# MINSMERE LEVELS STAKEHOLDERS GROUP

## **Response to the Second Stage Consultation of the Proposed Development of Sizewell C Nuclear Power Station**

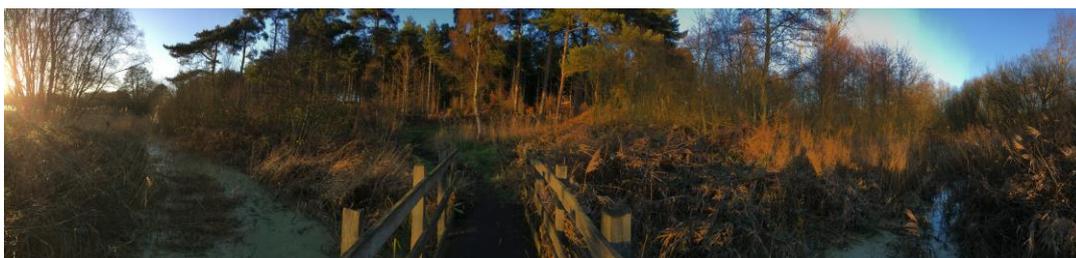
EDF Energy indicate (7.5.50) it is their intention to pump both treated foul water from the accommodation site and other on-site facilities along with any ‘excess run off’, collected in WMZs, from the main construction site into the sea through a temporary discharge facility which will terminate at the same distance as the ‘fish return’ (FR) outlet ~300 metres from the shoreline

- The WWTP, temporary discharge and FR facilities will not be available for a considerable amount of time after development starts
- No indication is given about how water from the WMZs will be managed and treated prior to their availability
- A full project schedule of this development is needed to ensure that waste water and run-off from the development site is properly managed at all stages of the development
